Subject: AP1000 Response to Request for Additional Information (TR 54)

Response to Request for Additional Information on Technical Report No. 54

RAI Response Number: RAI-TR54-026  
Revision: 1

The markup of DCD Rev. 17 Figure 9.1-4 below shows the modification in the tool storage area size.

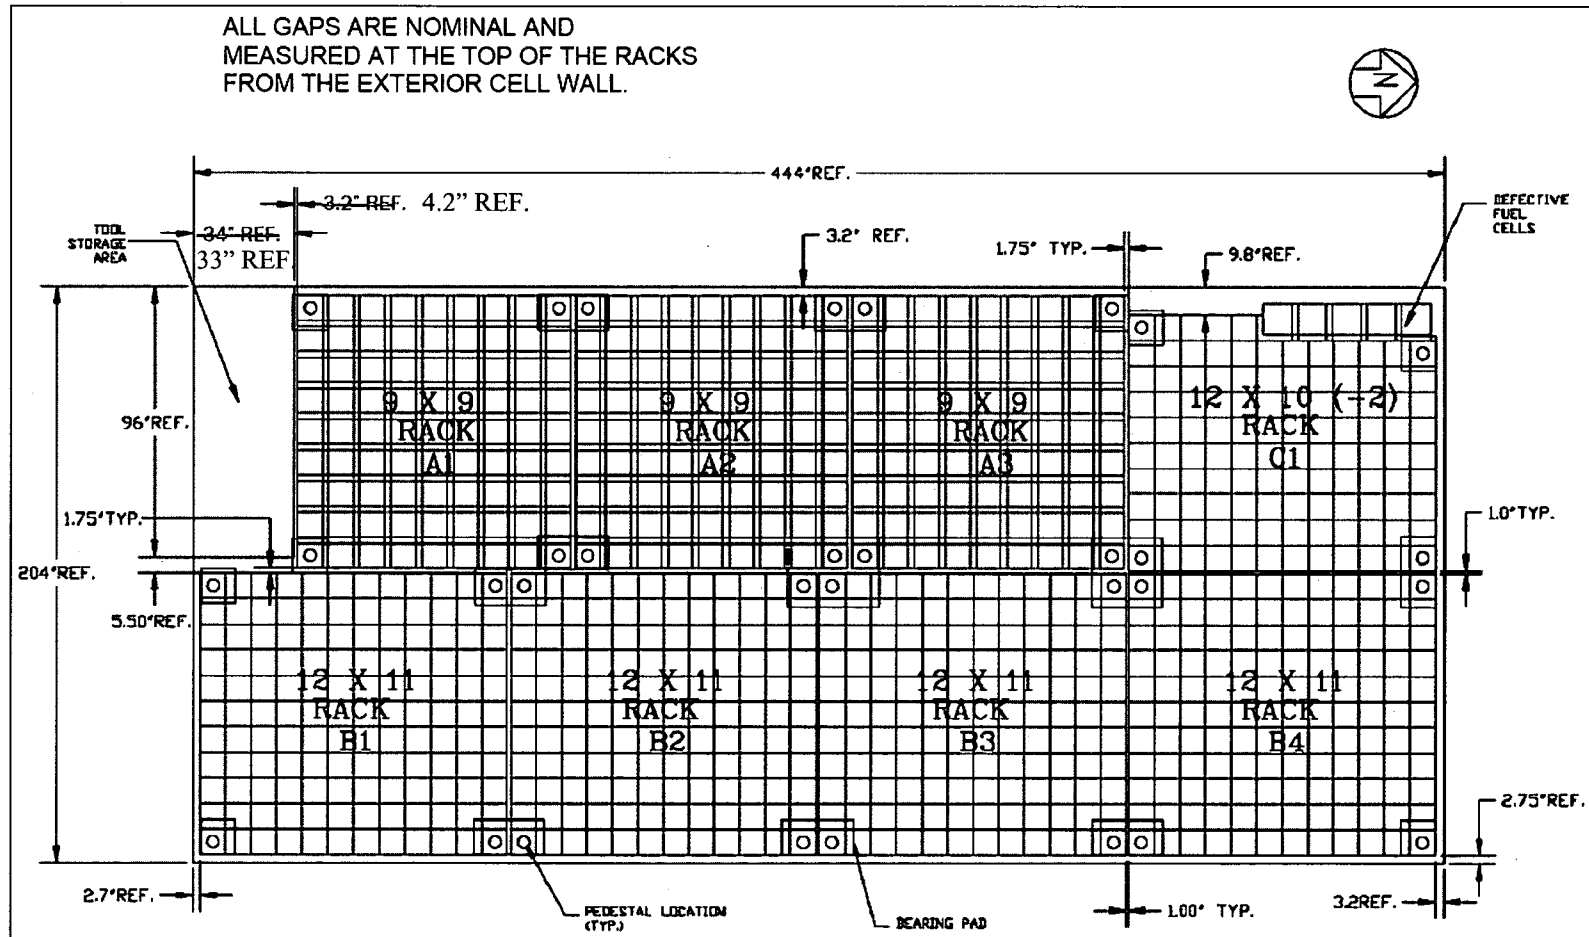
During the August 6-7, 2009 meeting with the NRC it was identified that spent fuel rack A1 is shown to slide into the area of the spent fuel pool designated as the "Tool Storage Area". To eliminate this from happening, the Tool Storage Area has been resized from 34 inches wide with a 3.2 inch gap from the tool storage area to rack A1, to 33 inches wide with a 4.2 inch gap. This increase in gap size precludes rack A1 from entering the tool storage area as the result of a seismic event.
